EXHIBIT E

Vogtle Units 3 and 4: Feasible and Cost-Effective Water Conservation Measures

Bill Powers, P.E., Powers Engineering

May 15, 2014

Figure 1. Schematic of Indirect Wet-Dry Cooling System⁵

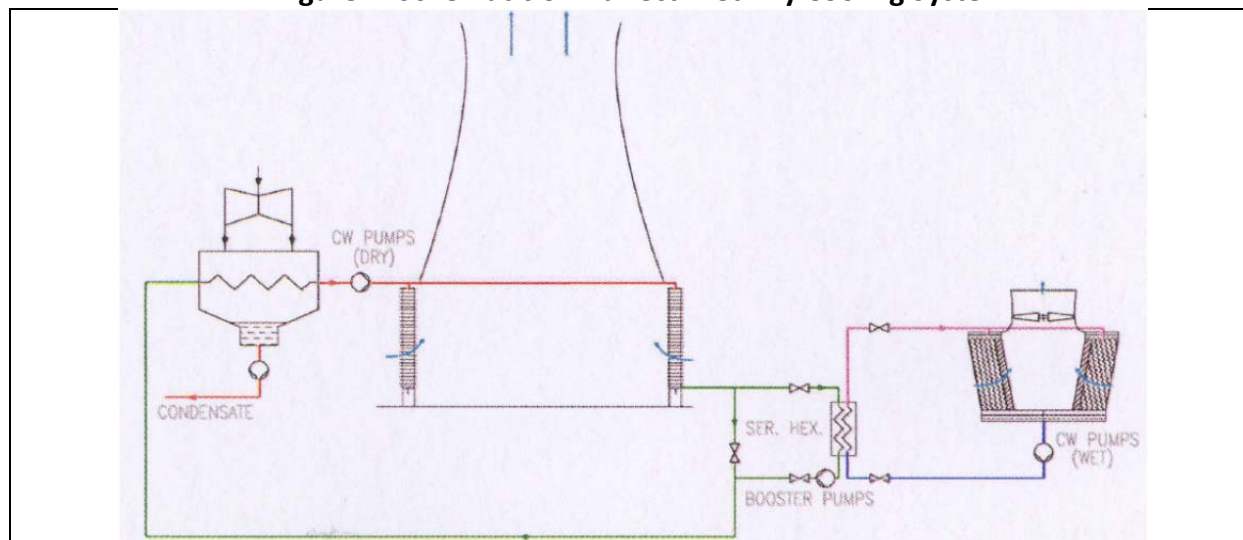
The indirect wet-dry cooling system consists of an air cooler, essentially a large radiator, located inside a hyperbolic natural draft cooling tower and a small wet cooling tower that work in combination to achieve the required cooling. An indirect wet-dry cooling is the best choice of retrofit air cooling retrofit options for Units 3 and 4. The indirect air cooler can use standard tube material and no modifications are required to the Unit 3 and 4 surface condensers. A schematic of the indirect wet-dry cooling system is shown in Figure 1.

Figure 4. Components of Indirect Wet-Dry Cooling System(s) on Units 3 and 4⁹

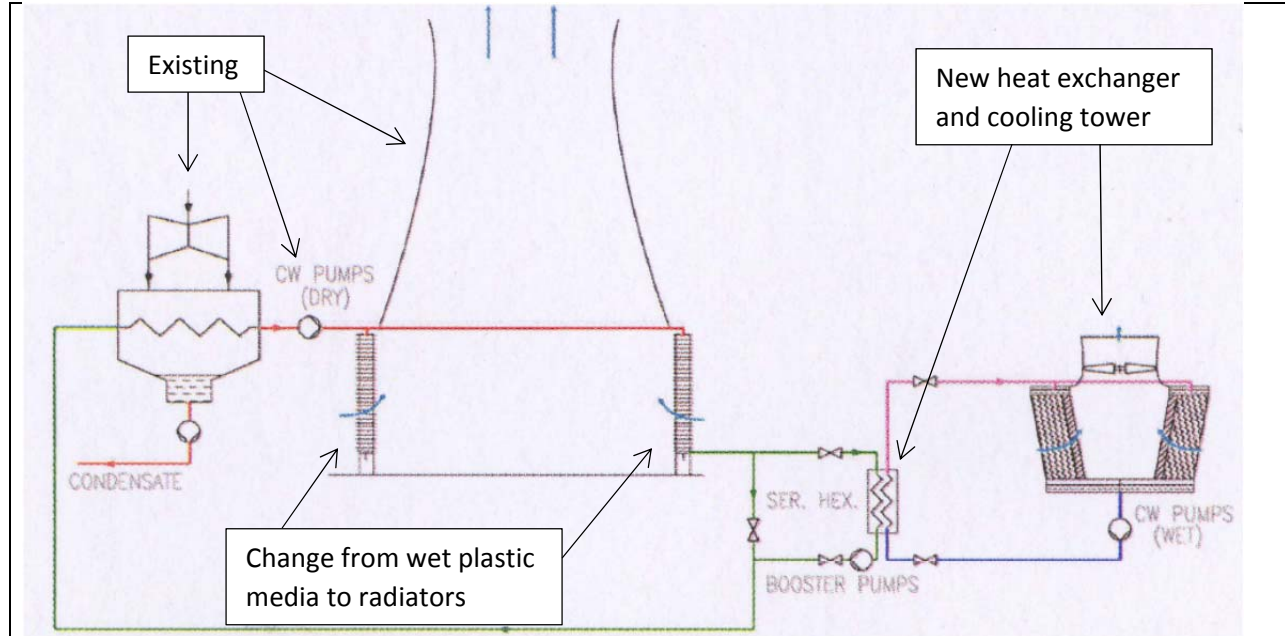
Figure 4 shows what components of a retrofit indirect wet-dry cooling system for use at Units 3 and 4 are part of the original Unit 3 and 4 cooling system design and what components would be additional.
